#### RE: DENDROBIUM MINE - RESPONSES TO BIODIVERSITY AND CONSERVATION DIVISION

In response to DPIE's letter dated 20 April 2020, please find below and enclosed South32's responses to residual comments made by the Biodiversity and Conservation Division (BCD) in its submission on the *Dendrobium Mine – Plan for the Future: Coal for Steelmaking EIS* (the Project) and associated Submissions Report, dated 9 March 2020.

Dendrobium Next Domain Project

Figure 1: Regionally Mapped Swamps

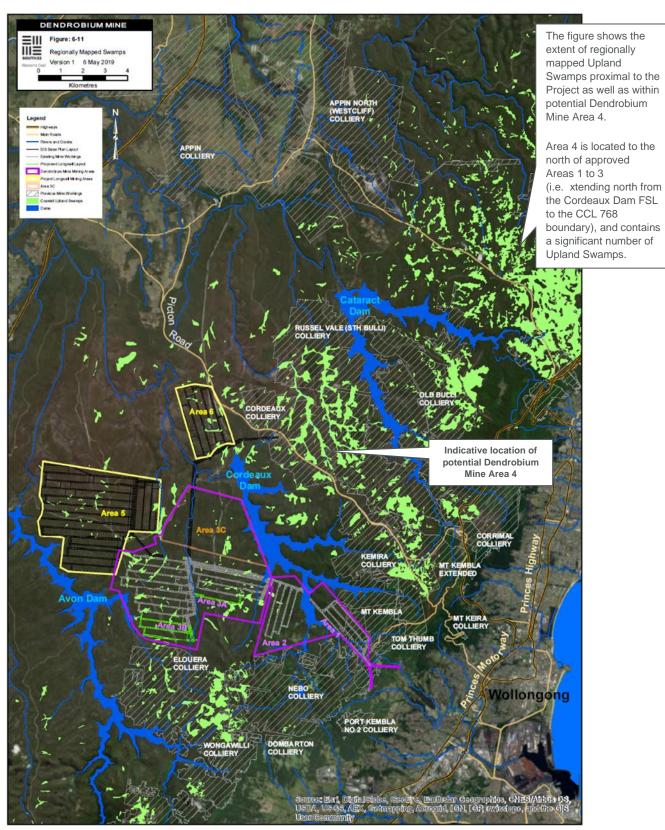
**Comment:** Accordingly, we maintain that the proposal does not sufficiently demonstrate that the "avoid" principle has been met, having regard to biodiversity assessment policy, guidelines and the SEARs, as per our EIS submission. In its current form the proposal is almost certain to have a significant impact on NSW and Commonwealth-listed water-dependent threatened species and ecological communities. The proposed longwall mining layout remains and the resultant associated subsidence will lead to adverse impacts to all tributaries and associated ecosystems that are adjacent or above.

As described above, the Project layout sets back from various natural and built features. In addition, the Project has considered the following to avoid potential impacts to Upland Swamps:

- The selection of proposed mining in Areas 5 and 6 as opposed to Area 4 (which is located within South32's existing CCL 768) (Figure 1).
- Surface infrastructure has been located to avoid direct impacts to Upland Swamps.
- The implementation of the mine constraints for the Project would result in avoidance of directly undermining a number of Upland Swamps including Den124, Den115, Den131, Den132, Den119 and Den134.
- Alternative longwall geometry/methods within Areas 5 and 6 have been considered, however, potential impacts to Upland Swamps are still expected for alternative longwall layouts (i.e. as subsidence impacts will still occur at 150 metre [m] wide panels) (MSEC, 2019a).

Accordingly, it is considered that reasonable avoidance measures have already been incorporated into the Project design, with residual impacts associated with the Project to be offset in accordance with Government policy.

Figure 2: Location of Swamp Den02

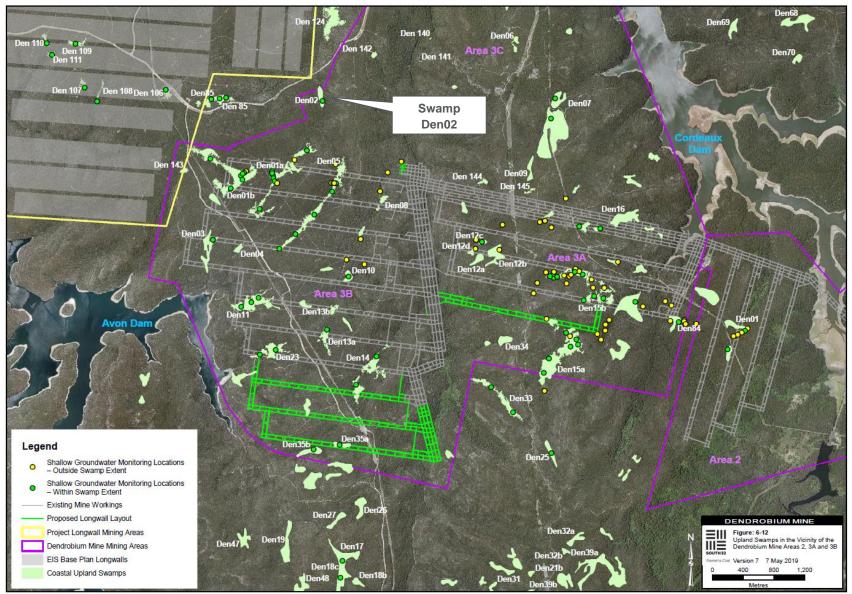
Comment: The FBA and Coastal Upland Swamp Offset Policy has been incorrectly applied in calculating the maximum predicted offset liability for Coastal Upland Swamps, and as a result the offset liability for Coastal Upland Swamp has been significantly under-estimated. The Upland Swamp Offset Policy requires calculation against a 'worst-case scenario' equating to total loss of swamps. This needed to be reflected in the applicant's approach.

- Approved impacts to 0.7 ha of Upland Swamp associated with Den02 have already explicitly been offset for the approved Dendrobium Mine (Figure 2).
  - The approval to impact Den02 would be relinquished for the Project.

- Accordingly, a net increase of 20.9 ha (i.e. 21.6 ha minus 0.7 ha) of Upland Swamps within 60 m of the Project longwalls would potentially be impacted for the Project (refer to Table 33 of Niche [2019]).

Figure 3: Proposed Surface Disturbance Area – West (Source: Niche, 2020)

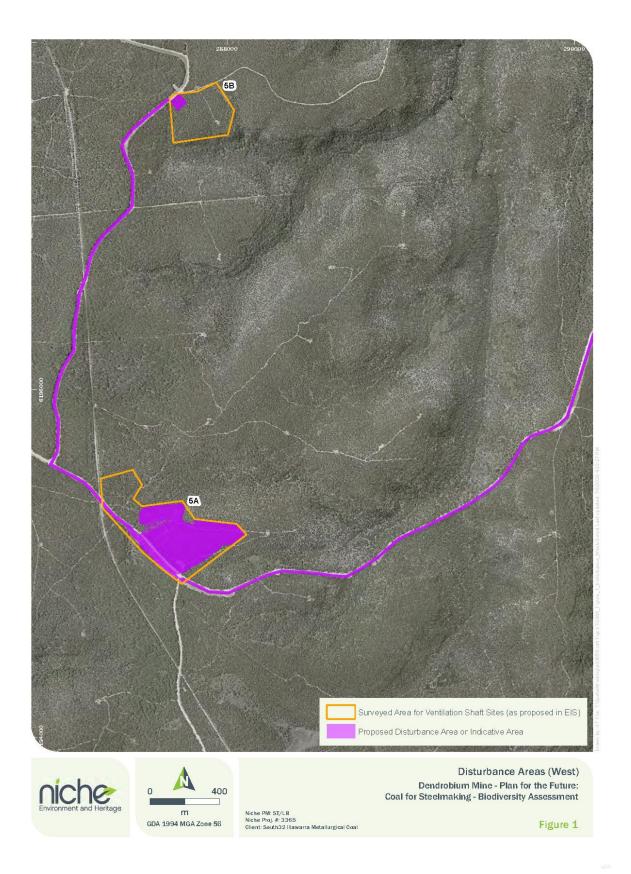
**Comment:** Issues remain with the FBA calculations for some threatened species, namely Koala, Powerful Owl and Eastern Pygmy Possum. Previous comments highlighted the inadequacy of assessment for areas where new surface infrastructure is proposed, and it is unclear why these have not been addressed.

In response to comments from BCD, and following further design work for surface infrastructure, the locations of service boreholes and electricity transmission lines have now been delineated (i.e. 'fixed'), and additional ecology surveys conducted accordingly (Figures 3 and 4). This results in:

- No change in total disturbance of 28.5 ha (Table 1).
- A proposed increase to Ventilation Shaft Site 5A to accommodate service boreholes and other design refinements (with reduced disturbance requirements at Ventilation Shaft Site 5B and the previous allowance for service boreholes accordingly) (Table 1).
- A reduction of approximately 1 ha in proposed disturbance of Shale Sandstone Transition Forest TEC (PCT 1395) (Table 2).

- Revised offset credit liabilities for ecosystem and species credits (Tables 3 and 4), with the additional survey work confirming:
  - Increased species credit liabilities for the Eastern Pygmy-possum and Rosenberg's Goanna (Table 4).
  - Confirmation of the species credit liability for the Koala (Table 4).
  - Confirmation that potential impacts to the Powerful Owl would be offset by ecosystem credits for PCT 1395/HN 556.

Figure 1: Upland Swamps in the Vicinity of the Project Mining Area

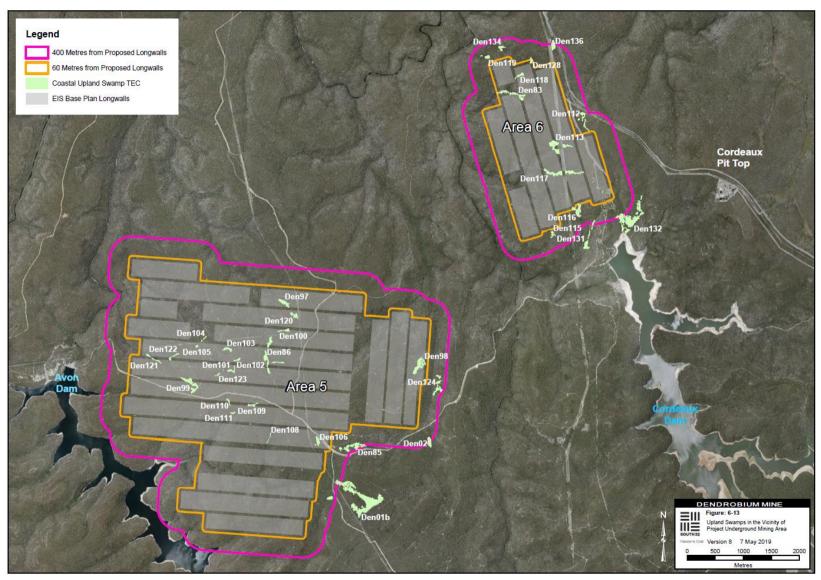
Comment 1: Avoidance of Impacts – proposed mining layout does not adequately demonstrate avoidance of impacts, particularly to Coastal Upland Swamp threatened ecological community and threatened frogs

Although it is acknowledged that subsidence and related impacts would be reduced under alternate mine layouts and extraction methods (approximately 150m wide panels), these are dismissed as being not feasible on economic grounds but without evidence or ability to verify the claim. No further evidence or discussion analysing alternatives in further depth has been provided.

- The implementation of the mine constraints and setbacks for the Project (i.e. from Dam walls, FSLs, named watercourses and key stream features) would result in avoidance of directly undermining a number of Upland Swamps including Den124, Den115, Den131, Den132, Den119 and Den134 (Figure 1).

Results – Tree Hollow Mapping (West)

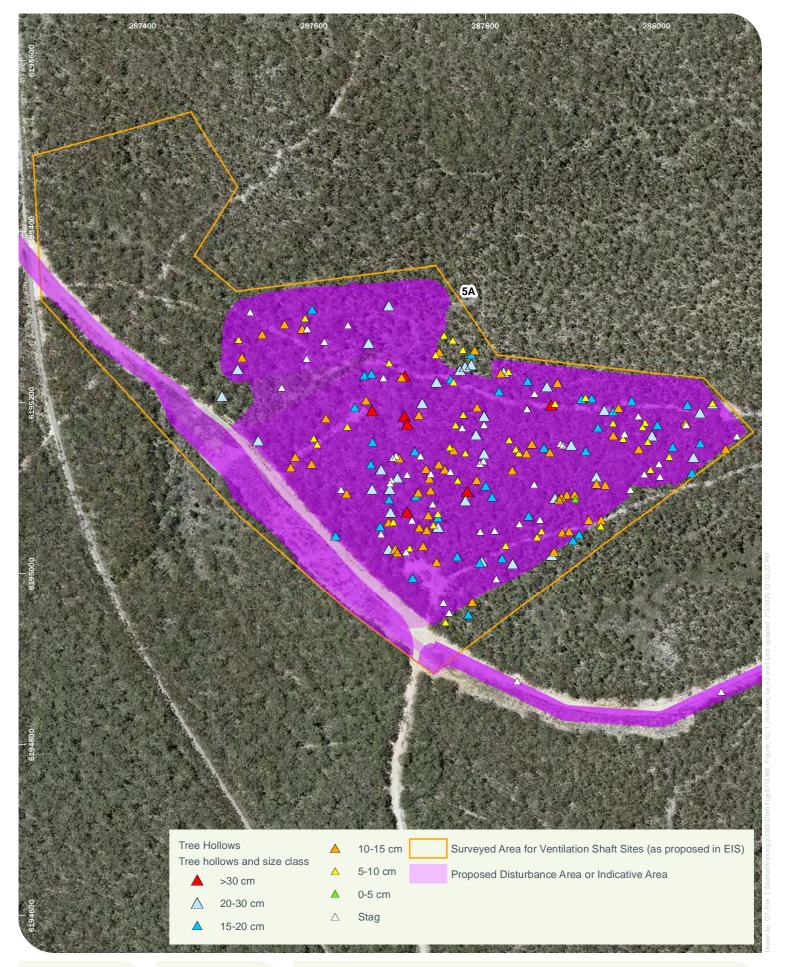
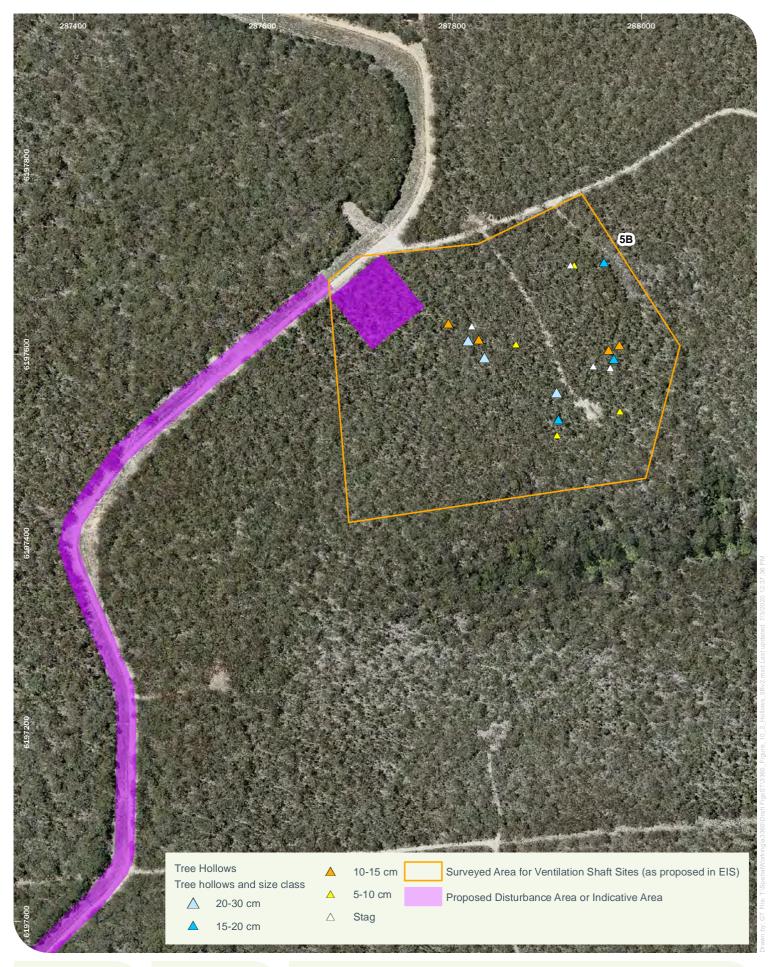
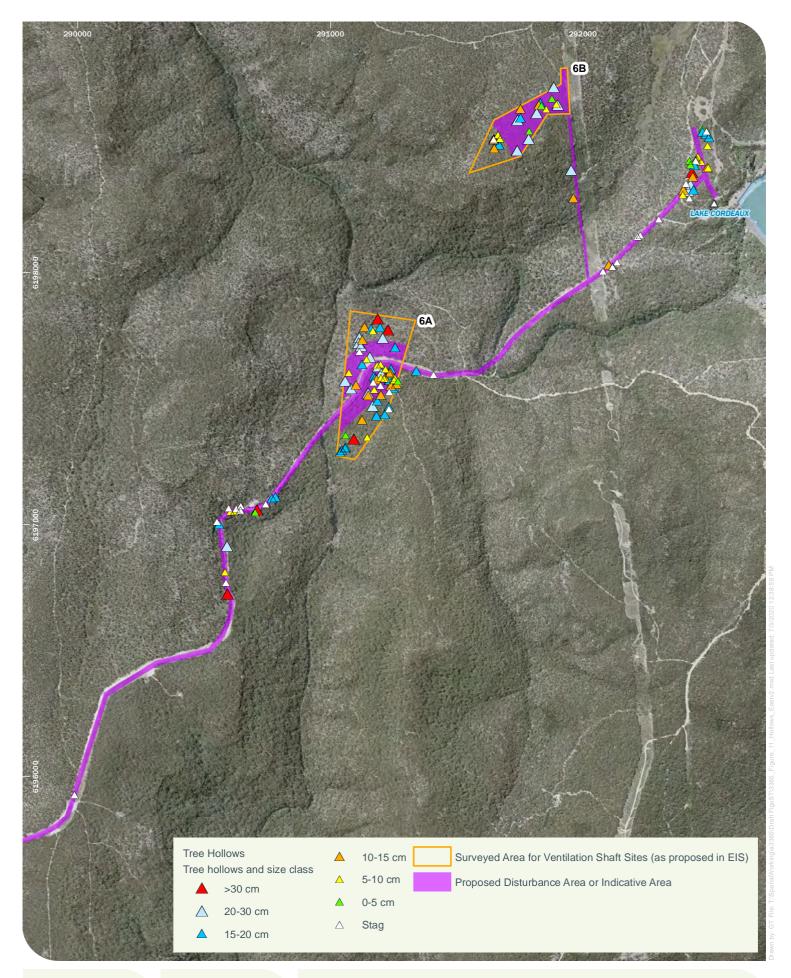
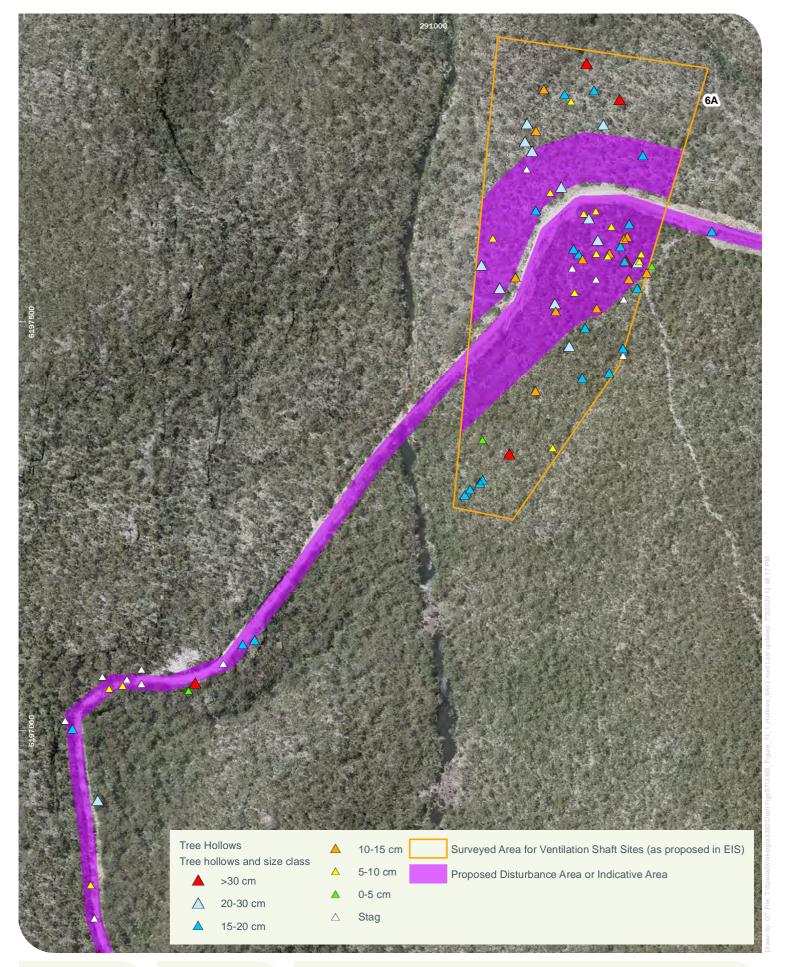
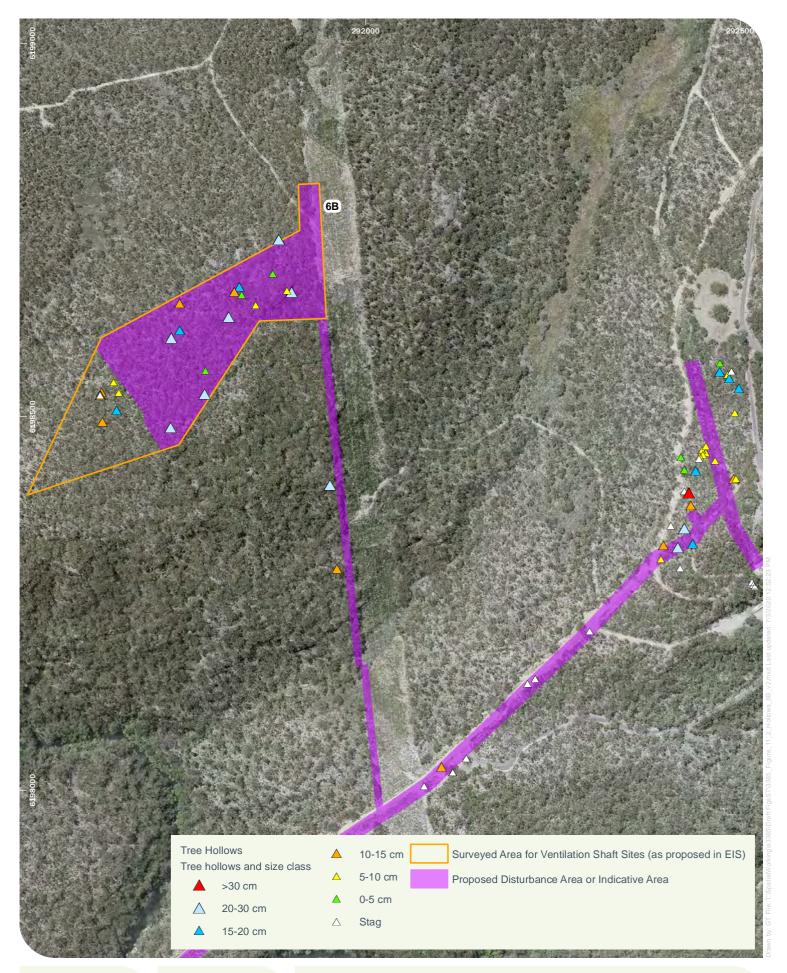
7	To date no map of hollow bearing trees has been supplied. A map of hollow bearing trees is required to ensure the key FBA component of avoiding biodiversity values is met, in addition to determining whether certain species credit species occur (eg powerful owl).	Hollow bearing trees have been mapped within areas of proposed clearing (Figure 10 and Figure 11). The capacity to avoid hollow bearing trees was limited due to their high densities within proposed ventilation shaft sites and wider catchment generally. The location of ventilation shaft sites were biased towards ridgetops, away from watercourses and other more ecologically constrained ecosystem types such as Shale Sandstone Transition Forest TEC.  There is a high abundance of hollows throughout the catchment area particularly in scribbly gum ( <i>E. racemosa</i> ) trees prevalent within the ventilation shaft sites. It was demonstrated that while hollows are abundant, hollow use is limited with a paucity of fauna recorded from ventilation shaft sites during repeated survey over months and years. This contrasts to fauna abundance in higher fertility areas of the study area including Shale Sandstone Transition Forest TEC, clearance of which is largely avoided by the Project.

Hollow bearing trees and stags were mapped throughout the development area (Figure 10 and Figure 11), indicating high densities of hollow bearing trees of varying size classes within remnant vegetation. The data reinforces data collected within Biobanking plots throughout areas to be cleared (see Appendix 4 of the BARBOS - Niche 2019).
